# A HEATSEAL Innovation

Therefore, we are proud to announce our latest innovation—an upgrade to Control Board 1818-001!

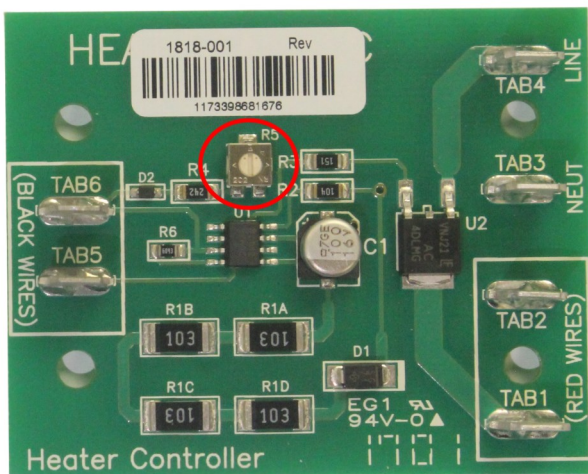
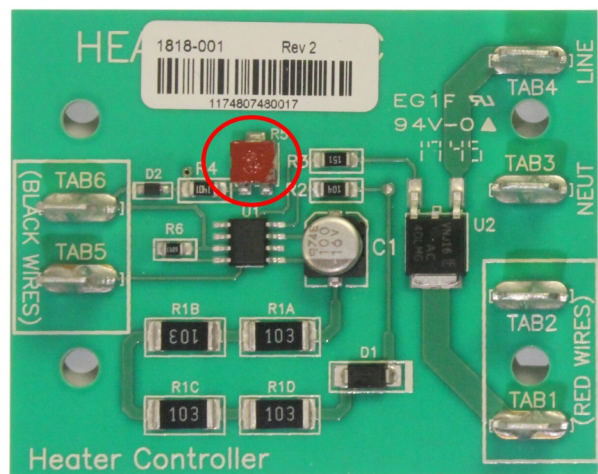
- Allow cutoff rod to accurately heat to optimal film cutting temperature (within 280°F and 305°F)
- Lower maintenance costs
- Extend machine service life
- Prevent cutoff rod from overheating
- Decrease the chance of film smoking

All 1818-001 Control Boards (shipped as parts and installed in machines) will be precisely set to regulate the heat cycle of the hot rod. We are securing this setting with a red tamper evident seal.
